Your ref: Tilbuster 2 Solar Farm (SSD-69799460)
Our ref: 12636761

16 June 2026

Tilbuster 2 Solar Farm Response to Submissions Report – Request for Additional Information

Annexure A – Flood Maps

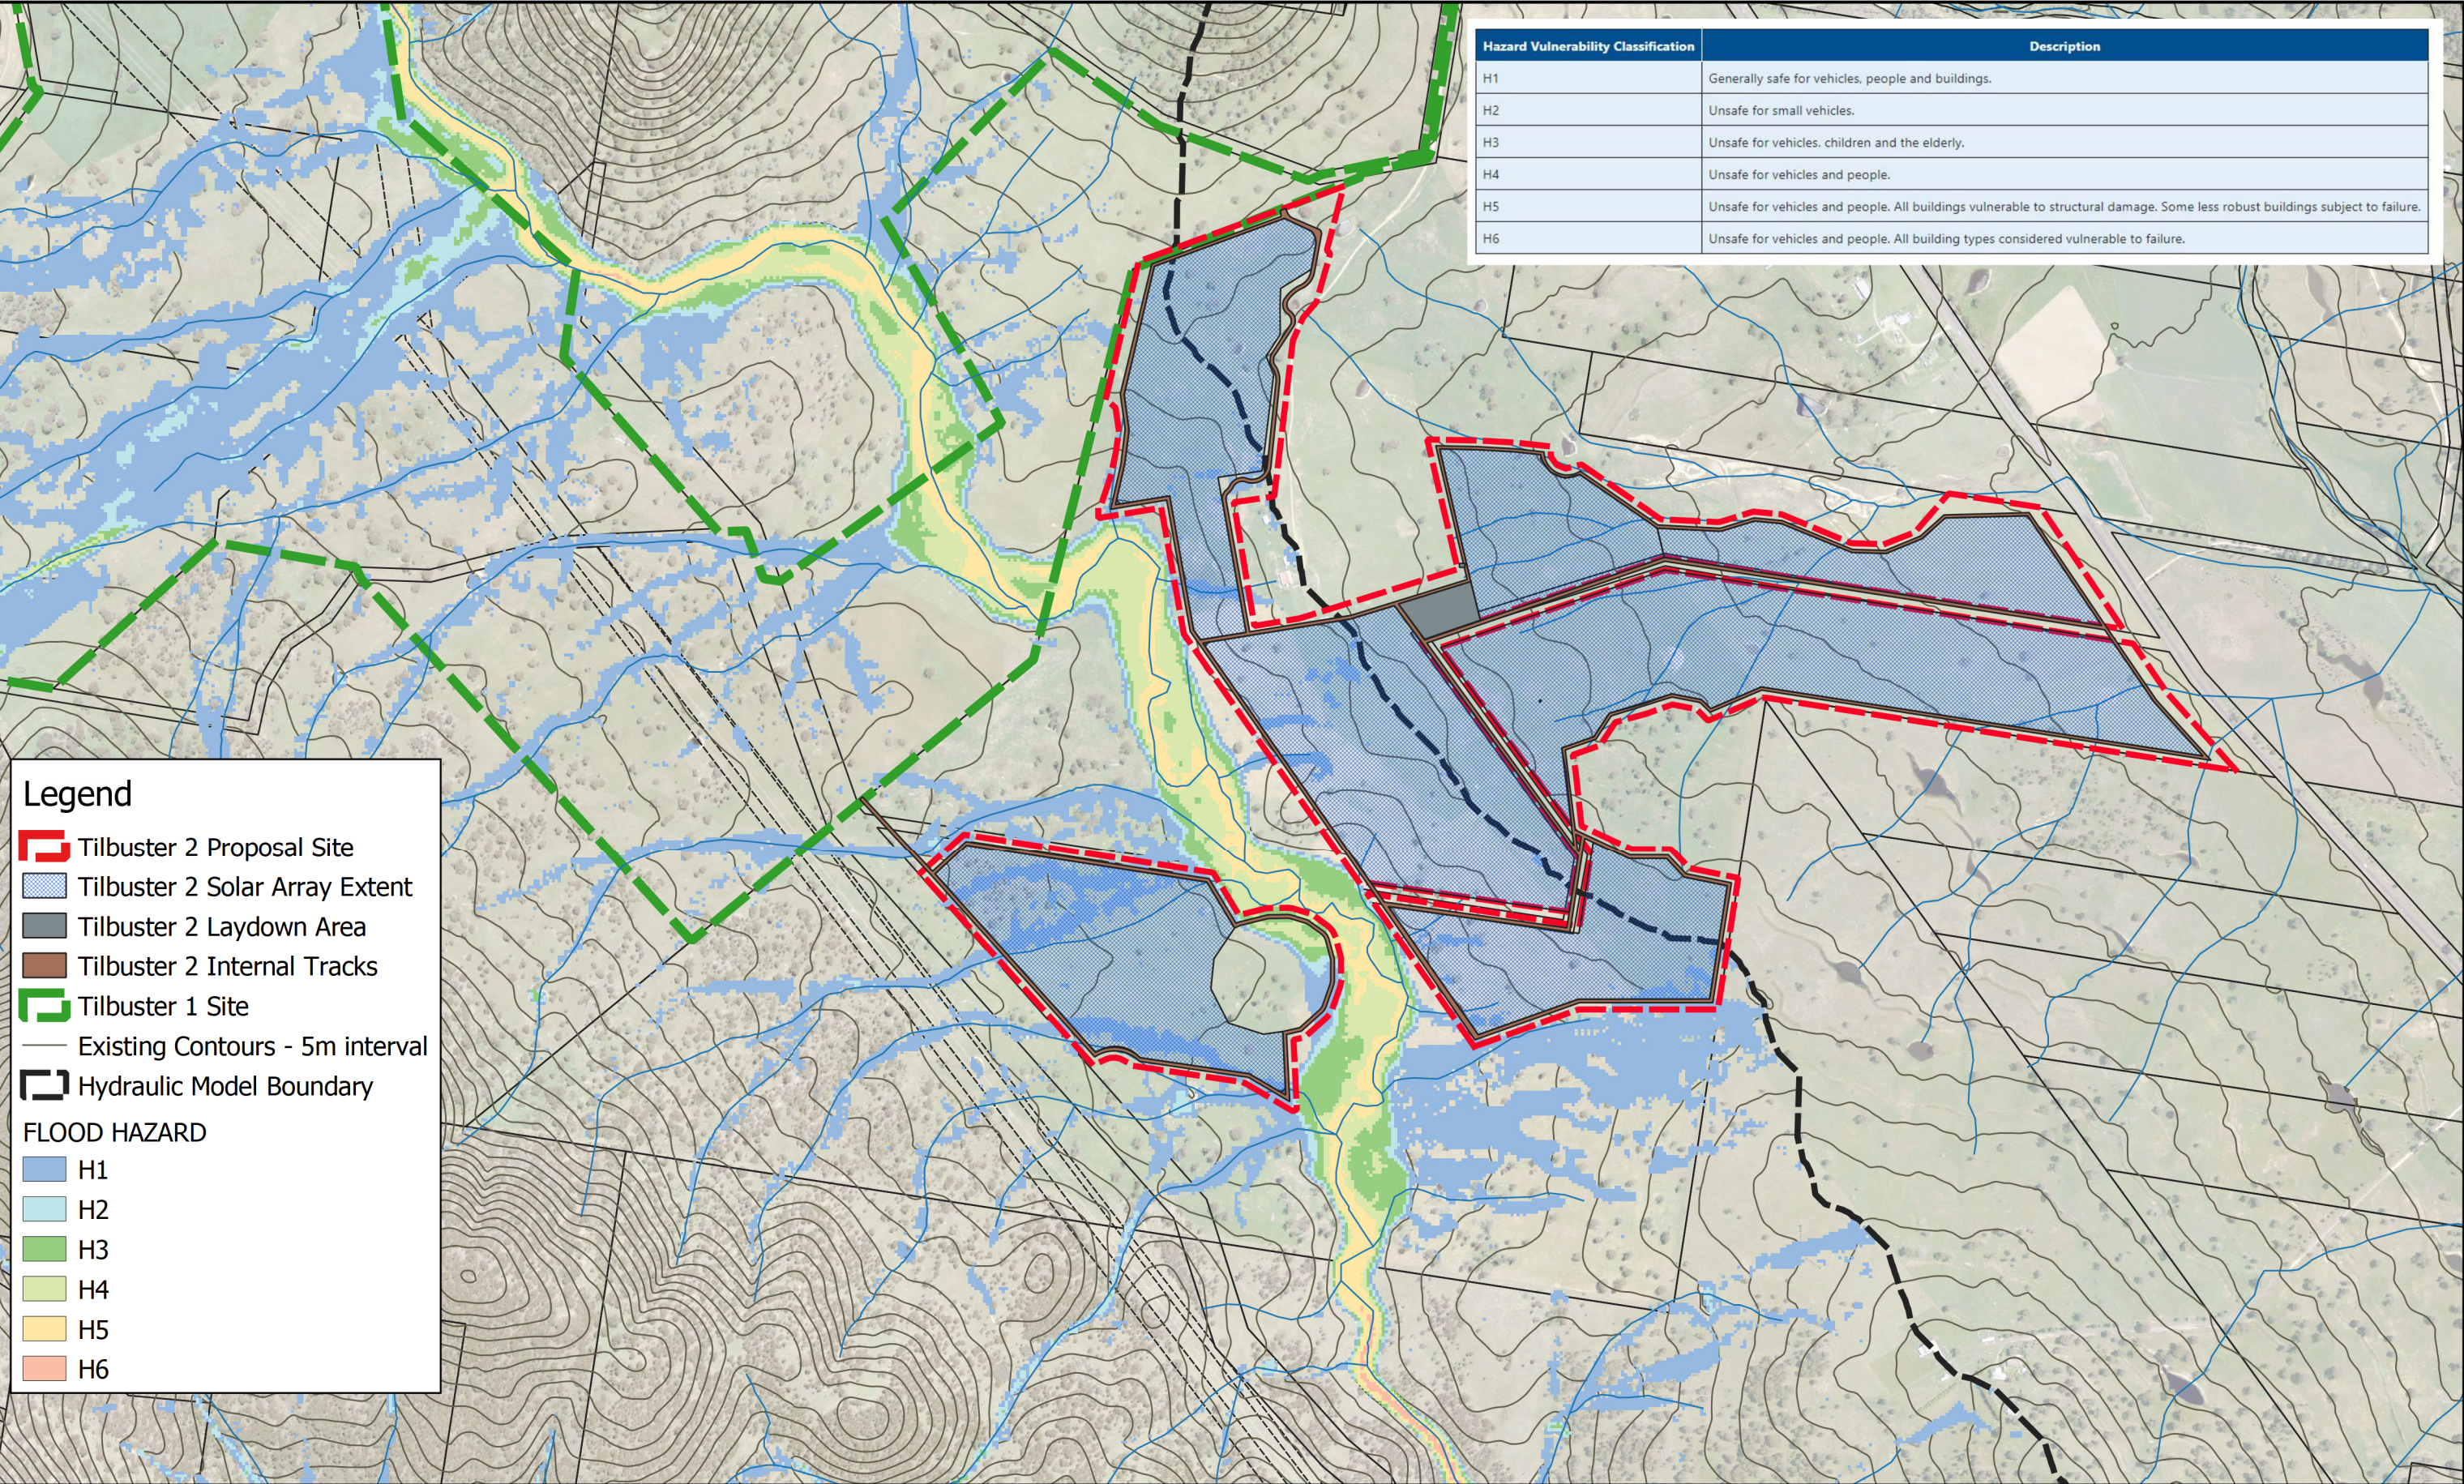
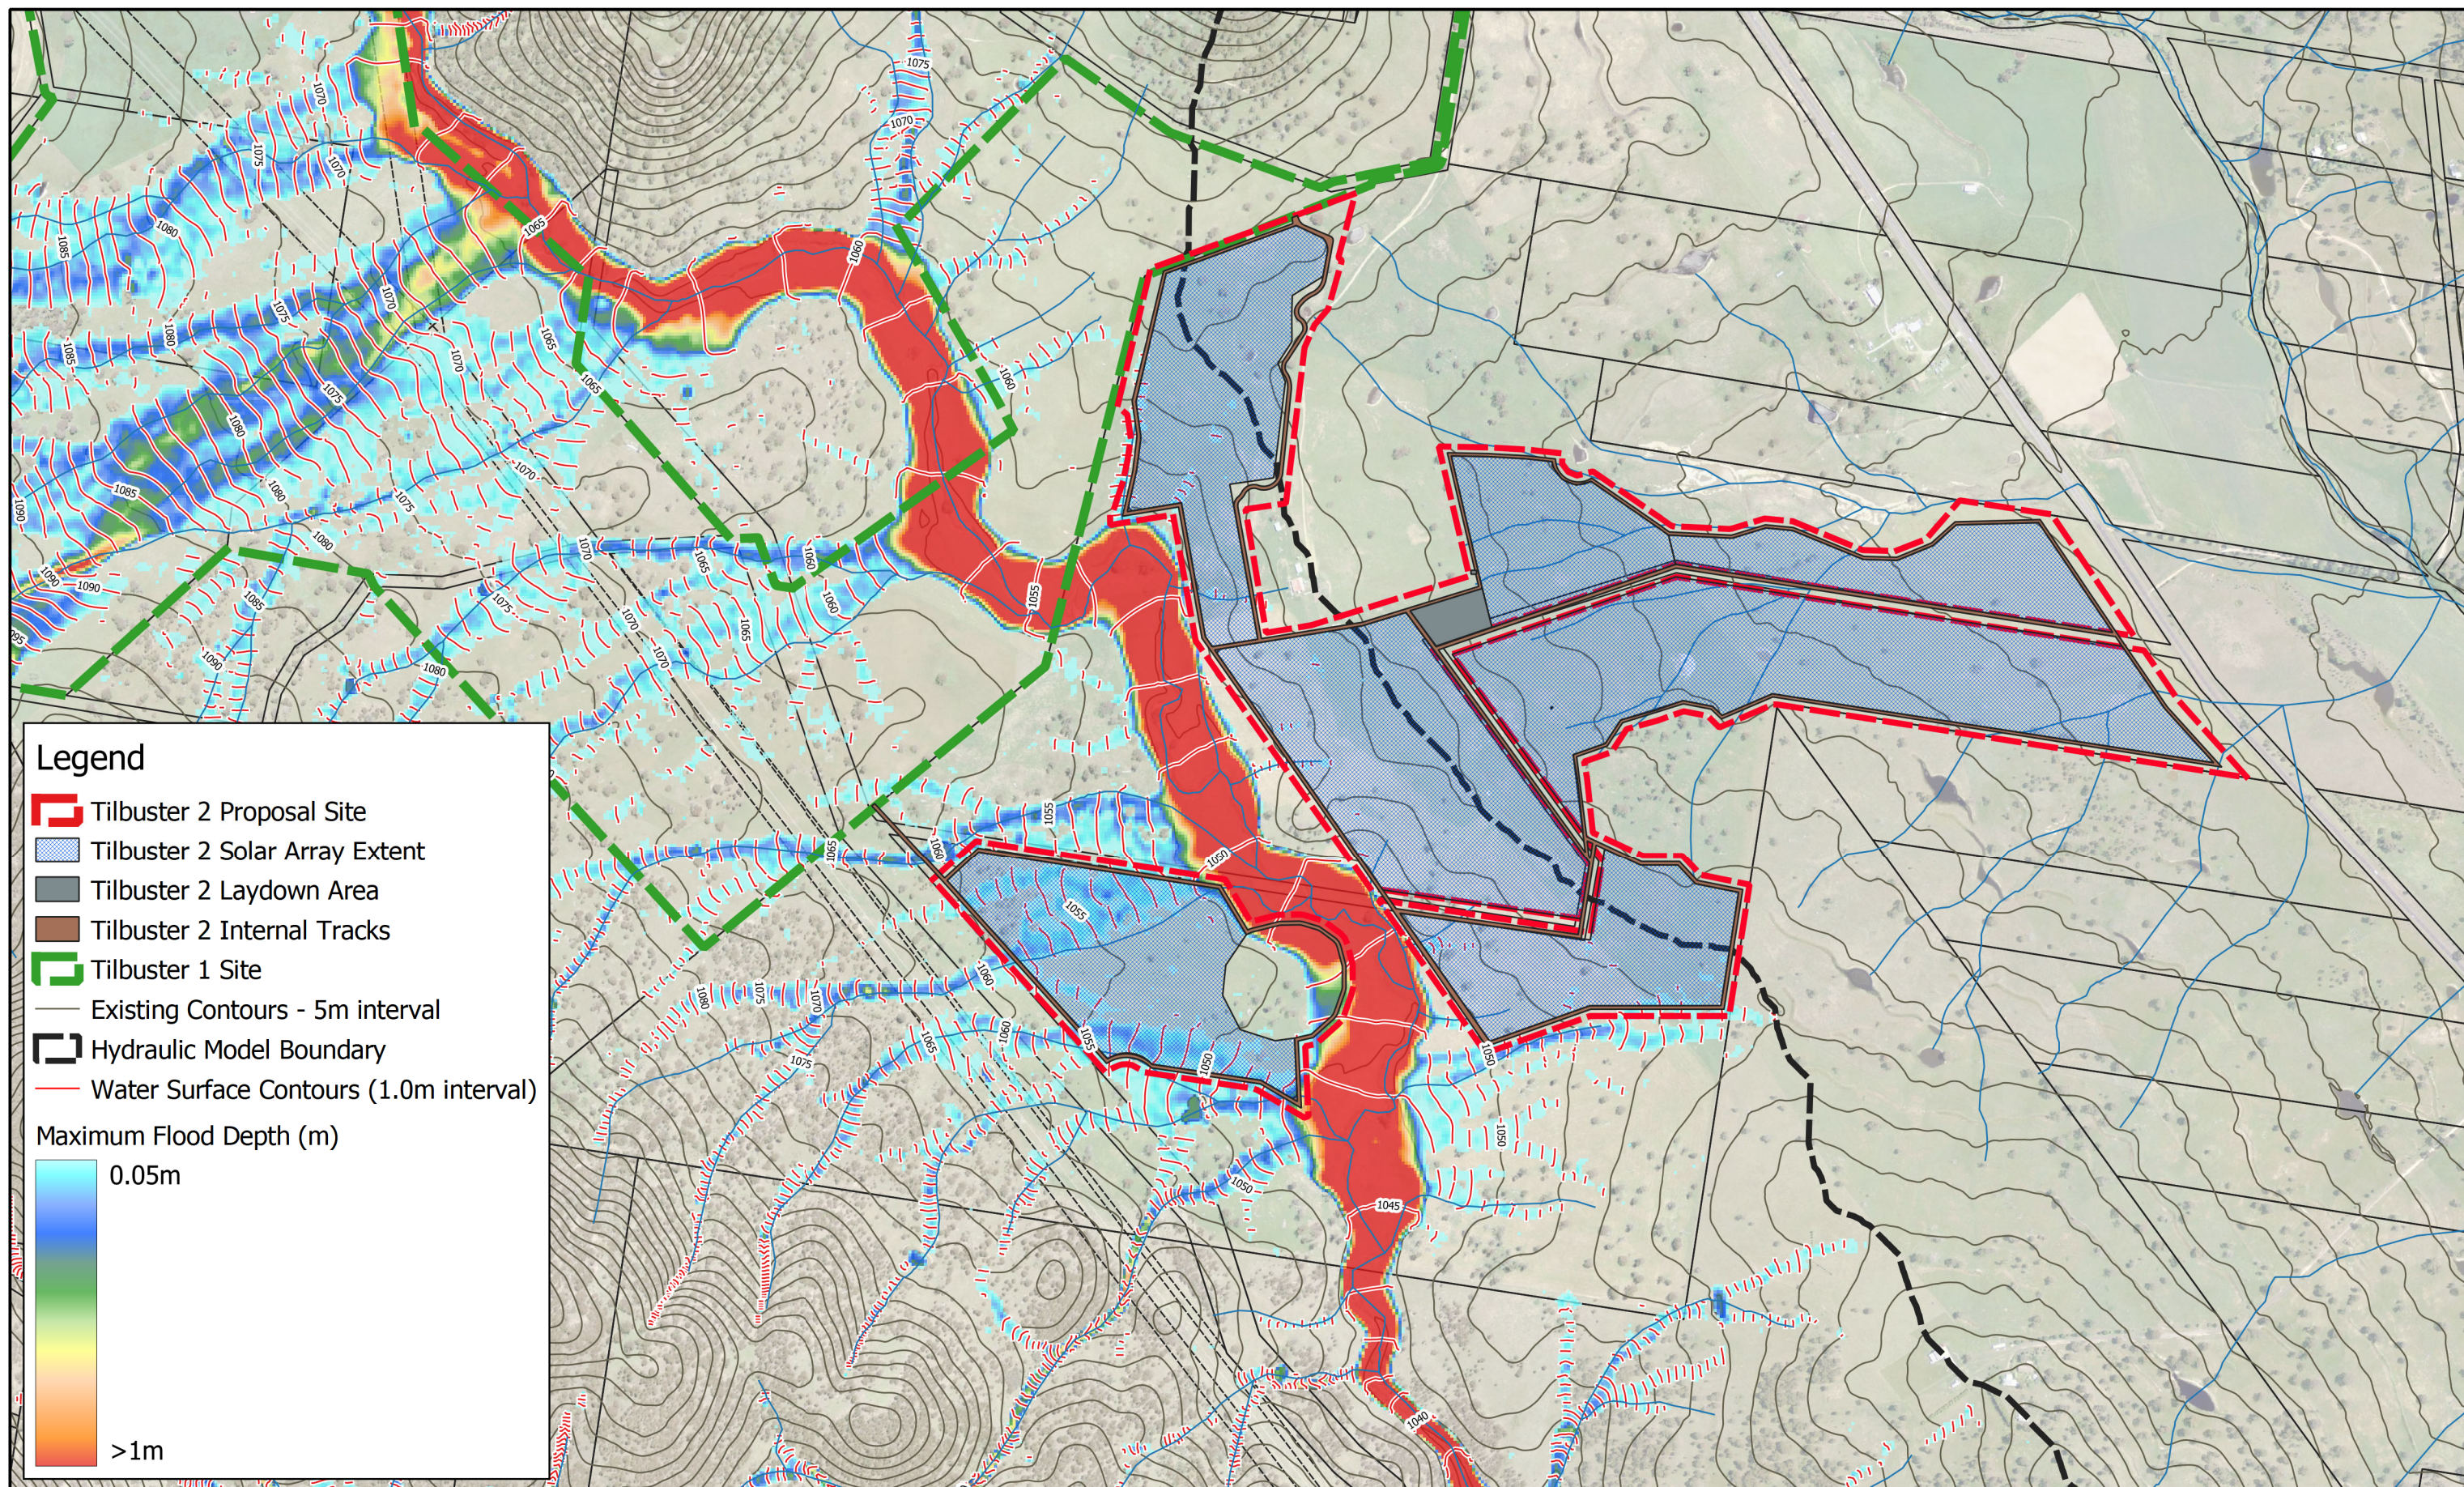
The Department of Planning, Housing and Infrastructure (DPHI) have requested pre and post development flood mapping for the proposal site. This is provided in Attachment 1.

The Tilbuster 2 site layout has been overlaid on the pre-development flood mapping prepared for the Tilbuster project and a copy of this mapping is included in Annexure A.

The figures show that the extent of the proposed solar array for Tilbuster 2 is typically clear of the extent of fluvial flooding associated with Duval Creek for the 5% AEP and 1% AEP events. Some areas on the western side of Duval Creek are impacted in the PMF event; however, these are generally outside the H6 hazard in that event. Otherwise, minor overland flooding is shown to occur through the solar arrays west of Duval Creek over first and second or watercourses (ephemeral depressions) in this area, however these flows are of low hazard (H1-H2) in all events.

Given that the proposed solar arrays are to be largely located outside areas of high flood hazard the proposed works are unlikely to result in an adverse impact on flooding within Duval Creek provided that the flood management recommendations contain in Section 6.0 of the Tilbuster Report are applied to this development.
